PERRY NUCLEAR POWER PLANT - UNIT 1

CABLE TRAY LAYOUT - WEST

REACTOR BUILDING FL. 620'-0" WEST

DRAWING NO.: D-214-332 G

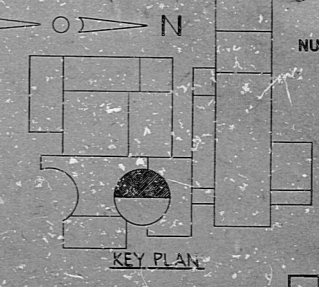
ADDED MPL NO TO (I) PENET AT COORD. J15
G P.C. ELIMINATION
 REMOVED DIMENSION AT EXPANSION SPICE PLATE ON TRAYS 622, 666 & 1126 AT COORD. J15. NOTE #5 AT COORD. J6.
F M. ELS. 11/11
 REMOVED COVER FROM TRAY #1662 AT COORD. E11
E M. ELS. 11/11
 REVISED SCHEDULE "B" TO INDICATE OUTSIDE EL.
D M. ELS. 11/11
 REVISED DIMENSION AT COORD. E7. CHANGED PERMANENT BARRIER AT COORDS. E11, F11, G11, H12. CHANGED EIM NO. TO EIM NO. AT COORD. J15. REVISED TRAY #1623 AT COORD. D10. DELETED TRAY #1610 AT COORD. D11.
C M. ELS. 11/11
 ADDED EXPANSION CONNECTORS AT COORD. F11. ADDED DRYWELL WALL & C.V. PENETRATIONS. ADDED NOTES 2 & 4. ADDED TRAY COVER TO TRAY #222 AT COORD. F11. DELETED TRAY #1614. REVISED TRAY #1627 AT COORD. E12. REMOVED END PLATE & CHANGED ELEV. OF TRAY #224 AT COORD. E11. ADDED TRAY #1623 & DELETED TRAY #1610 AT COORD. E10. REVISED TRAYS #163, 1616, 1618 AT COORDS. E5 & E6. TRAYS #121, 1118 AT COORD. E11.

B M. ELS. 11/11
 CHECKED DWG FOR CONSTR. REMOVED TRAY #1610 FROM ELEV. 620' & 1112. ADDED TRAYS AT COORDS. D10, E5, E6, F10 & E11. REVISED TRAYS AT COORDS. D10, E11, E12, F11, F12 & 1112. ADDED TRAYS #1623 & 1112.
A M. ELS. 11/11
 CHECKED DWG FOR CONSTR. REMOVED TRAY #1610 FROM ELEV. 620' & 1112. ADDED TRAYS AT COORDS. D10, E5, E6, F10 & E11. REVISED TRAYS AT COORDS. D10, E11, E12, F11, F12 & 1112. ADDED TRAYS #1623 & 1112.
